DATE: 5-3-16

APPLIES TO: This service bulletin applies to 2011 through 2016 model year chassis cabs altered by Spartan Motors, USA Inc. between November 16, 2011 and March 1, 2016.

CONDITION: Exhaust components may contact with rear upper/lower chassis cross members.

CORRECTION: Adjust exhaust routing.

FIG. 2-1

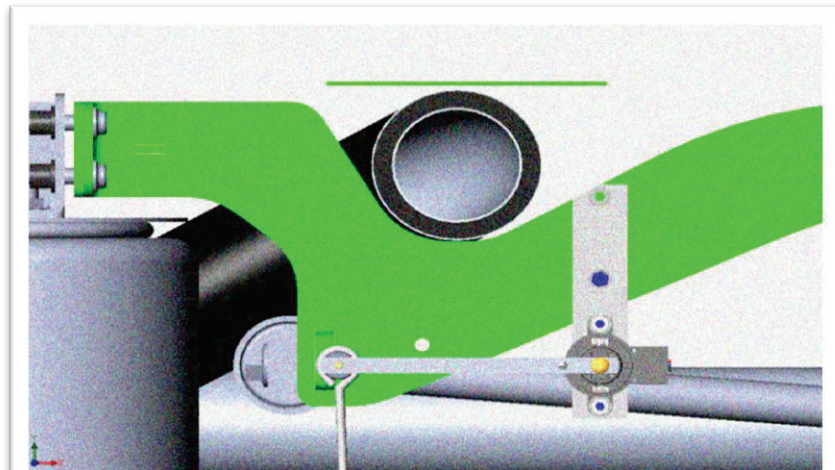
1. Band clamps and rear muffler mount must be loosened to allow manipulation of pipe. Refer to FIG. 2-1.

2. Adjust position of pipe down and away from upper cross member detail and tighten front band clamp. Refer to FIG. 2-1.
3. Adjust the bottom position of pipe and move away from lower cross member to provide a gap. Before tightening up make sure that upper and lower cross member both have a gap. Tighten band clamp and exhaust hanger. Refer to FIG. 2-2.

FIG. 3-2

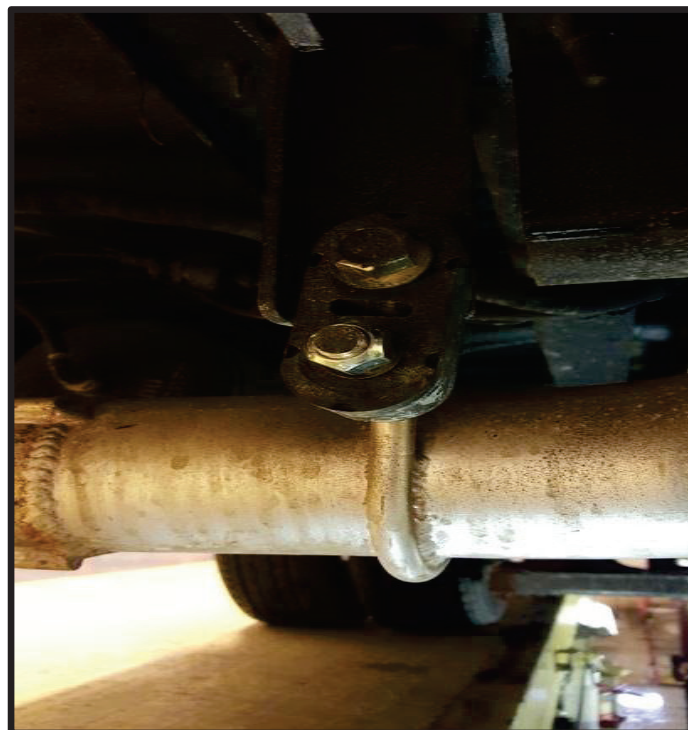
5. Place 1/2 X 13 lock nut on end of hangers. Refer to FIG. 3-2.
